REMARKS

Reconsideration of the application in view of the above amendments and the following remarks is requested. Claims 2-5, 8-10, 26, 33-36, and 45-55 are in this application. Claim 6 has been cancelled. (Claims 1, 7, 11-25, 27-32, and 37-44 were previously cancelled.) Claim 52 has been amended to correct an inadvertent error. Claims 2-5, 8-10, and 45-49 have been allowed.

FIG. 12B

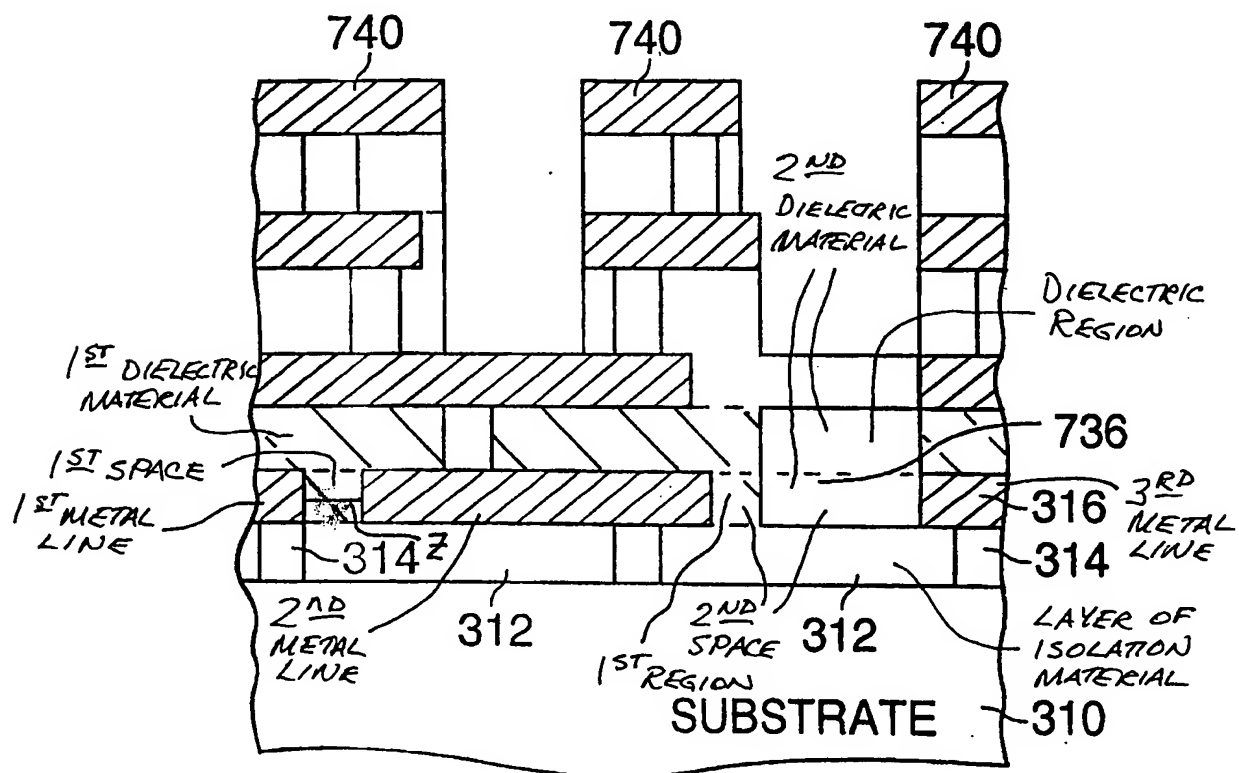
"The specification (fig. 12b) discloses the first dielectric material (312) lies in a portion of a first region that lies horizontally between the second and third metal lines. Additionally, the specification (figure 12b) also shows

another dielectric material (736) lies between the portion of a first region of second and third metal lines. Therefore, how can the first dielectric material (312) lies horizontally entirely between the second and third metal lines when another dielectric material (736) lies in the same horizontal between the second and third metal lines?"

Applicant has included an annotated version of applicant's FIGs. 12B to aid in the following discussion. With reference to the annotated drawing, FIG. 12B shows an isolation layer, which is labeled "layer of isolation material", and a metal-1 layer with a left metal line, a center metal line, and a right metal line that are labeled first, second, and third metal lines, respectively.

In addition, FIG. 12B shows an area labeled first space, which is defined to lie between the first and second metal lines, and an area labeled second space, which is been defined to lie between the second and third metal lines. Applicant brings the

Examiner's attention to the fact that the second space lies "horizontally entirely between the second and third metal lines." Further, within the second space, an area labeled first region has been defined to contact the side wall surface of the second metal line.

FIG. 12B also shows a dielectric material layer, which is the hatched region labeled first dielectric material, and a dielectric structure, which is labeled second dielectric material. In addition, within the dielectric structure (labeled second dielectric material), a dielectric material block, labeled dielectric region, can be defined.

Thus, FIG. 12B shows a layer of isolation material, first, second, and third metal lines, a first dielectric, and a second dielectric. Further, FIG. 12B shows first and second spaces, a first region, and a dielectric region. As a result, applicant's specification necessarily discloses a layer of isolation material, first, second, and third metal lines, a first dielectric, and a second dielectric, along with first and second spaces, a first region, and a dielectric region.

Applicant notes that claim 26 does not recite that the first dielectric material lies horizontally entirely between the second and third metal lines. Rather, claim 26 recites that a first region lies horizontally entirely between the second and third metal lines. Applicant further notes that, like the first region shown in the annotated version of FIG. 12B, there is nothing in claim 26 which requires that the first region of claim 26 occupy all of the volume that exists between the second and third metal lines.

Claim 26 recites that the first region lies horizontally entirely between the second and third metal lines, and that the first dielectric material lie in the first region. The annotated version of FIG. 12B shows that the area labeled first region lies horizontally entirely between the second and third metal lines (and does not consume all of the volume that lies horizontally entirely between the second and third metal lines), and that the first dielectric material lies in the first region.

FIG. 5B

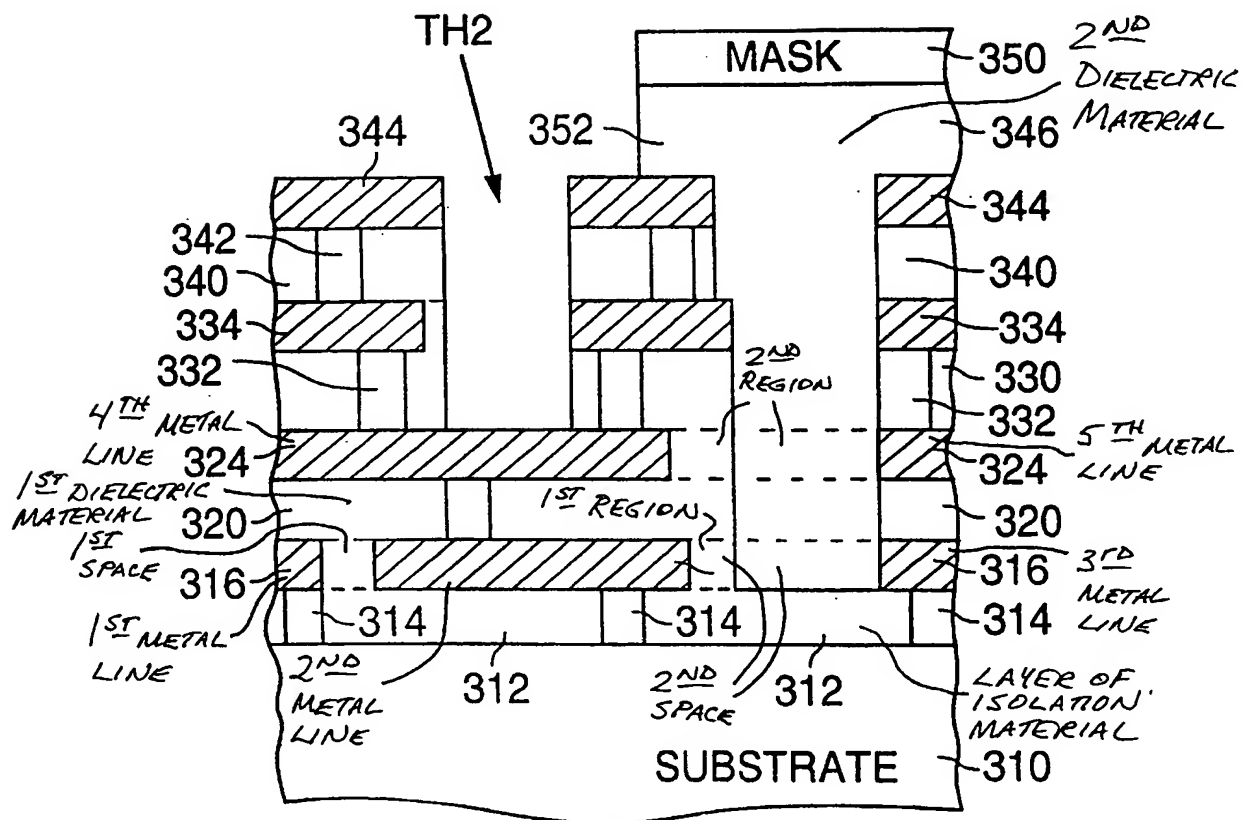
"The specification never discloses the second dielectric material is formed over the second region as claimed in claim 36. The specification (fig. 12b) discloses the second dielectric material is formed on the fourth metal line and the fifth metal line."

With respect to claim 36, applicant notes that all of the comments set forth above regarding FIG. 12B apply equally well to applicant's FIG. 5B. Thus, claim 26, which claim 36 depends from, reads on both FIGS. 5B and 12B. Applicant has included an annotated version of applicant's FIGS. 5B, which has been marked in the same manner as FIG. 12B, to aid in the following discussion.

With reference to the annotated drawing, FIG. 5B shows a dielectric structure, which is labeled second dielectric material. In addition, a space labeled second region is defined to lie between the fourth and fifth metal lines. Applicant brings the Examiner's attention to the fact that the second region shown in the annotated version of FIG. 5B lies "horizontally entirely between the fourth and fifth metal lines."

In addition, as shown in FIG. 5B, a portion of the second dielectric material lies on and over the second region. FIG. 5B does not show that all of the second dielectric material lies on and over the second region, but claim 36 does not require this. Claim 36 only requires that the second dielectric material lie on and over the second region, which is what is shown in FIG. 5B.

Applicant, however, is unclear which structure the Examiner is reading to be the second dielectric material. Thus, from what applicant can determine, claim 36 is supported by applicant's FIG. 5B and thus satisfies the requirements of the first paragraph of section 112.

**FIG. 5B**

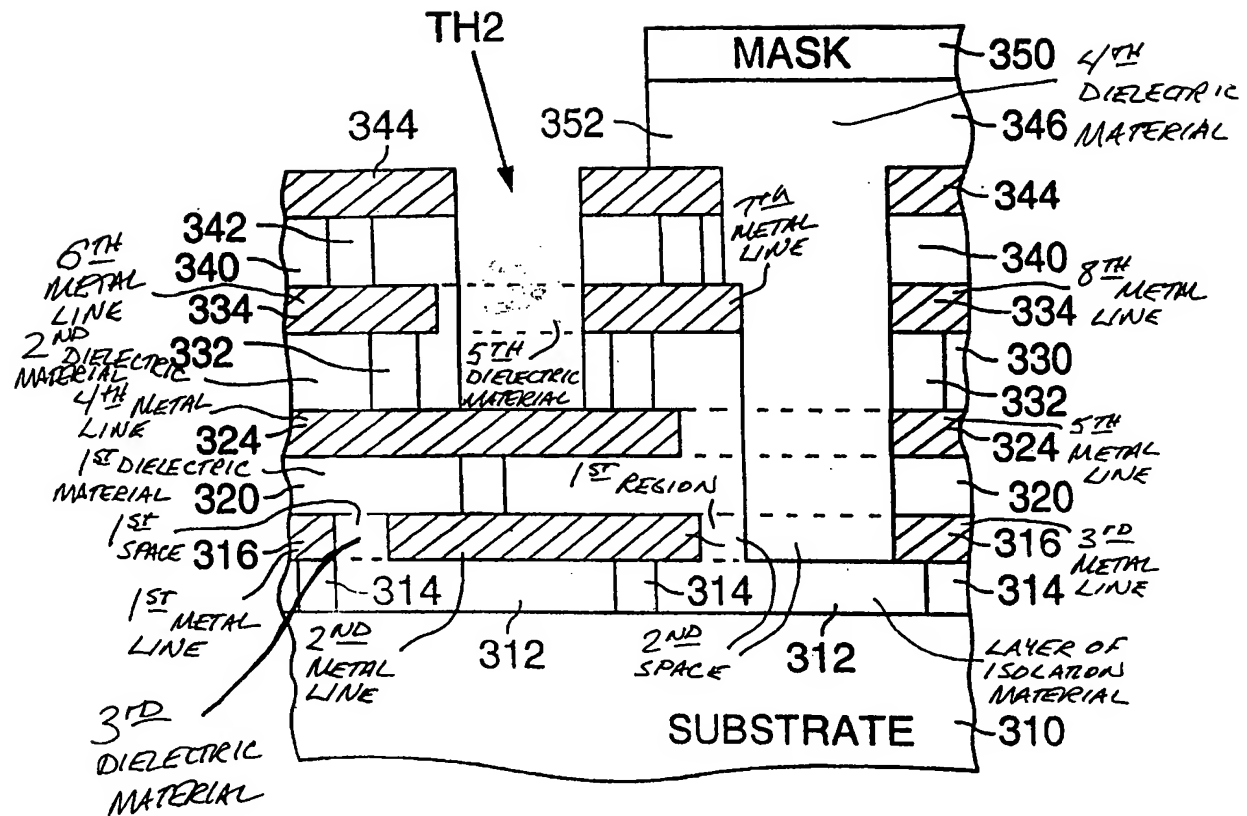
"The specification never discloses a fourth dielectric material formed between the second and third metal lines and the fourth and fifth metal lines as claimed in claim 50. How can the fourth dielectric material (346) [be] formed between the second and third metal lines when another dielectric material (312) [is] formed between the second and third metal lines? There are two portions of two dielectric materials (one is 346 and another is 312) formed between the second and third metal lines."

"The specification never discloses [that] the third dielectric material is also formed within a region that lies in the first horizontal plane between the second and third metal lines as claimed in claim 54. How can the third dielectric material (the dielectric material that lies between the left and center metal lines of metal-1 layer 316) [be] formed within a region that lies in the first horizontal plane between the second and third metal lines when another dielectric material (346) [is] formed within a region that lies in the same plane between the second and third metal lines (figure 5B)?

It appears from the Examiner's comments that the Examiner believes that claim 50 requires that all of the volume that lies between the second and third metal lines be filled with the fourth dielectric material. Applicant, however, is not aware of any limitation in claim 50 that requires all of the volume that lies between the second and third metal lines be filled with the fourth dielectric material.

Rather, claim 50 requires that the fourth dielectric material be formed between the second and third metal lines, and between the fourth and fifth metal lines. As shown in the second annotated version of FIG. 5B, the fourth dielectric material is formed between the second and third metal lines, and between the fourth and fifth metal lines. This does not, however, prevent another dielectric material from also lying between the second and third metal lines.

As with the discussion of claim 50, claim 54 does not require that the third dielectric material occupy all of the volume that lies between the second and third metal lines. With respect to claim 55, the Examiner appears to have rejected claim 55 because claim 50 was rejected. Thus, from what applicant can determine, claims 50-55 satisfy the requirements of the first paragraph of section 112.

FIG. 3B

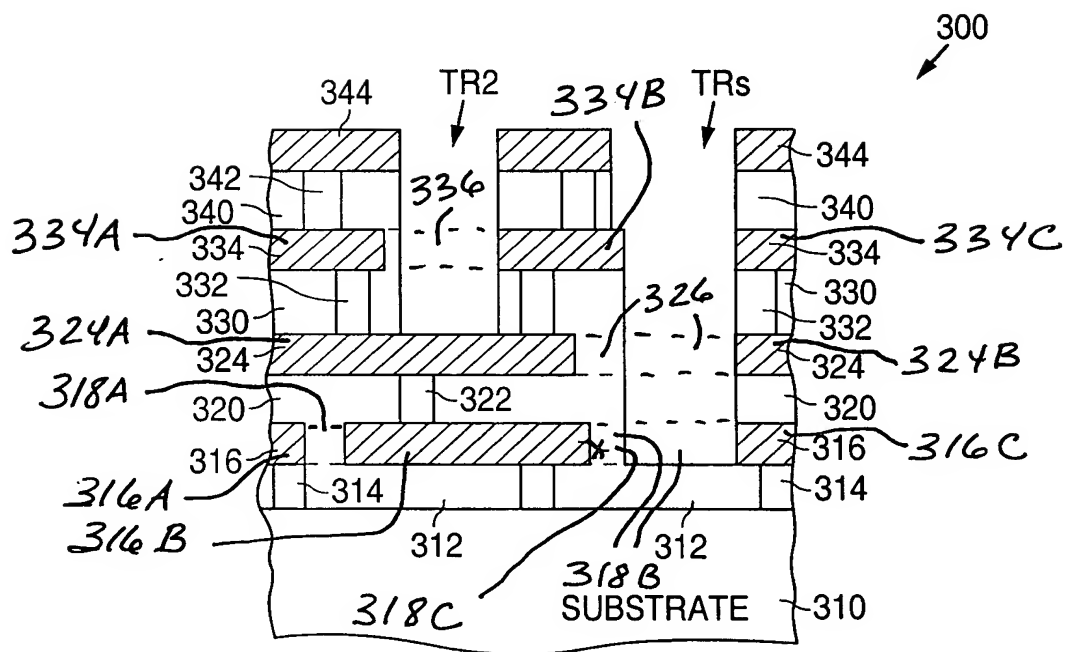
Applicant requests the Examiner's permission to make the changes shown in red on the annotated copies FIGS. 3B, 4B, 5B, 6B, 7B, 8B, 9B, 10B, 11B, and 12B attached to this amendment in Appendix A. The changes to the drawings include the addition of a number of reference numerals to label structures shown within the drawings. The specification has also been amended to reflect the changes to the drawings. In addition, applicant has also attached a replacement set of drawings in Appendix B that include replacement sheets for the figures which have been amended, along with copies of the formal drawings filed on July 30, 2002.

FIG. 6B

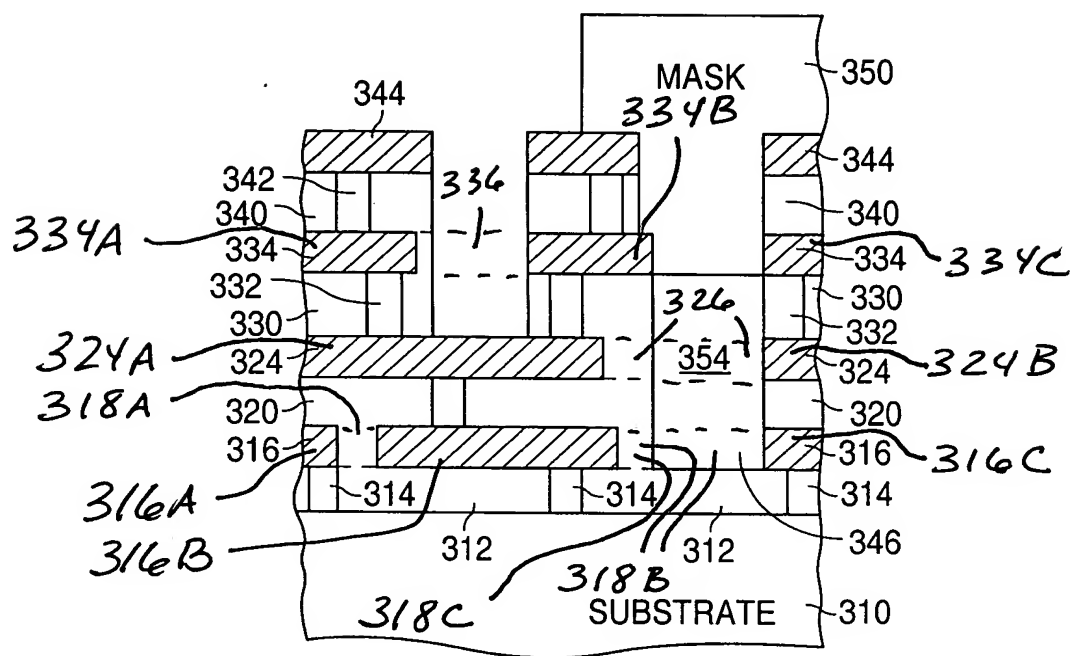
With respect to claim 51, in the last amendment, applicant explained how the sixth dielectric material can be read onto applicant's FIG. 6B. In the present office action, the Examiner indicated that applicant's argument was not convincing because the fourth and sixth dielectric materials are the same. The Examiner also stated that the sixth dielectric material can not be an air dielectric.

Applicant respectfully does not understand the Examiner's arguments. From the Examiner's comments, applicant can only assume that the Examiner believes that for some reason FIG. 6B can not be used to provide support for claim 51. However, applicant does not know if this assumption is correct and, if correct, why the Examiner believes this. Applicant knows of no reason why FIG. 6B can not be
